Access Compliance Report

Public Rights-of-Way

(Curb Ramps)

Intersection ID: 4420	Main Street: LARKHULL_DR	Cross Street: TRINITY_RD	Location:	S
ADA ID: 1D9FC4511247	Ramp Type: Perp	Initial Pass/Fail: Fail	Overall Compliance: No	Severity Score: 8.75
Codes/Mitigation Info/Possible Solution		Field Measurements/Component Compliance

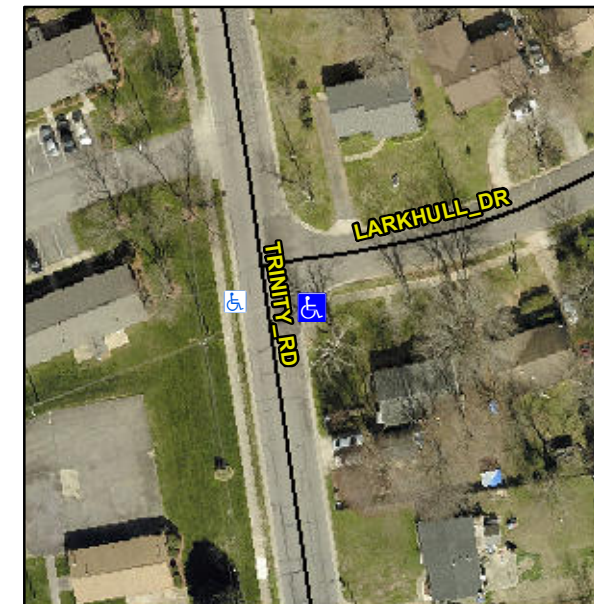
Not Found, R304.5.1

Compliance	Description	Data	Compliance	Description	Data
N/A	Ramp Length (in)	70.5	Yes	Ramp Slope (%)	7.7
No	Ramp Width (in)	40.0	Yes	Ramp XSlope (%)	1.4
N/A	Flare Type LT	N/A	N/A	Flare Type RT	N/A
N/A	Flare Slope LT (%)	N/A	N/A	Flare Slope RT (%)	N/A
N/A	Flare Traversable LT?	N/A	N/A	Flare Traversable RT?	N/A
N/A	Landing Length (in)	N/A	N/A	DWS Provided?	N/A
N/A	Landing Width (in)	N/A	N/A	DWS Contrast?	N/A
N/A	Landing Slope (%)	N/A	N/A	DWS Length (in)	N/A
N/A	Landing X Slope (%)	N/A	N/A	DWS Full Width?	N/A
N/A	Landing Curb? (Y/N)	N/A	N/A	DWS Offset (in)	N/A
N/A	Shared Landing?	N/A			
N/A	Gutter Ponding?	N/A	N/A	Gutter Slope (%)	N/A
N/A	Gutter Lip Ht (in)	N/A	N/A	Gutter X Slope (%)	N/A
N/A	Painted X Walk1?	No	N/A	Painted X Walk2?	N/A
	X Walk 1 Direction	To N		X Walk 2 Direction	N/A
N/A	X Walk 1 Width (in)	N/A	N/A	X Walk 2 Width (in)	N/A
	X Walk 1 Slope (%)	7.2		X Walk 2 Slope (%)	N/A
	X Walk 1 X Slope (%)	0.7		X Walk 2 X Slope (%)	N/A

Remove & Replace Entire Ramp.
